MR #2023016 – BOWIE MILL ROAD BIKEWAY

NO. MR2023016

Completed: 1/10/2024

- Montgomery County Department of Transportation to construct a sidepath along Bowie Mill Road between Olney-Laytonsville Road and Muncaster Mill Road and along the Muncaster Mill Road between Bowie Mill Road and Needwood Road.

Figure 27: Area of Shared Maintenance under Memorandum of Understanding within Bowie Mill Local Park

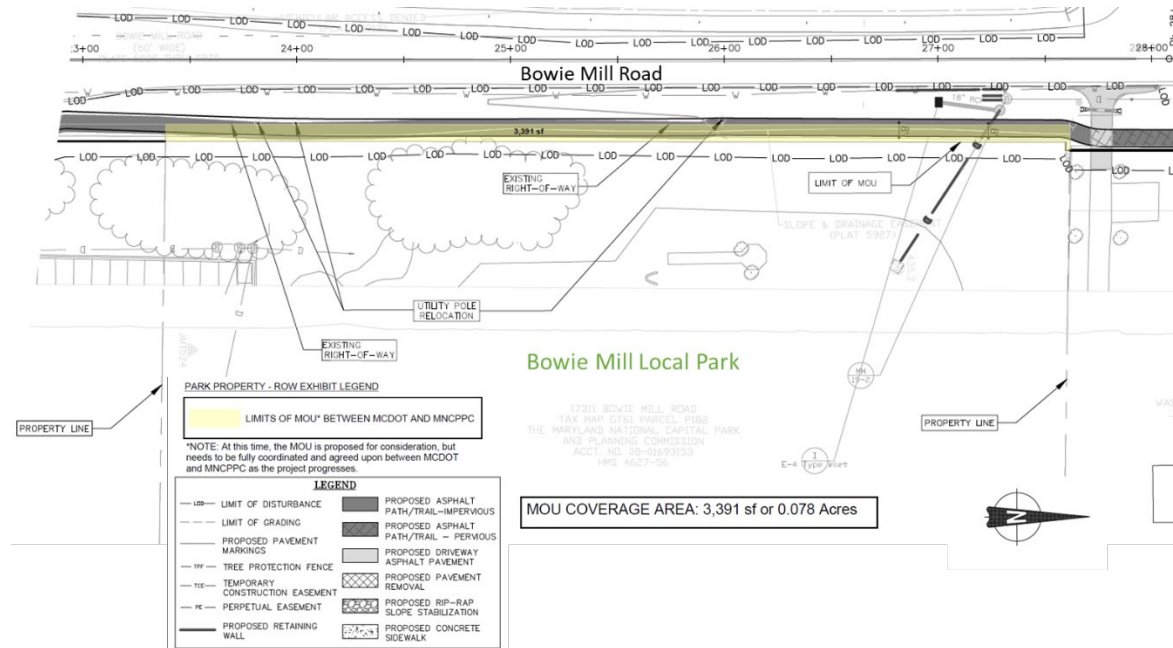
Recommendation: MCDOT and Montgomery Parks will continue to coordinate on a Memorandum of Understanding (MOU) at Bowie Mill Local Park regarding access and maintenance of the portion of the sidepath and lighting on parkland, which must be agreed to and finalized before the issuance of a Park Construction Permit.

Along the frontage of Bowie Mill Local Park, the sidepath and lighting will be located on park property. A Memorandum of Understanding (MOU) will be utilized at Bowie Mill Local Park and no perpetual easement will be granted (Figure 28). The MOU will establish the agreed upon maintenance responsibilities between MCDOT and Montgomery Parks in the shared maintenance area on parkland,

which will include approximately 3,390 square feet of parkland. MCDOT will be responsible for the maintenance of the sidepath and lighting.
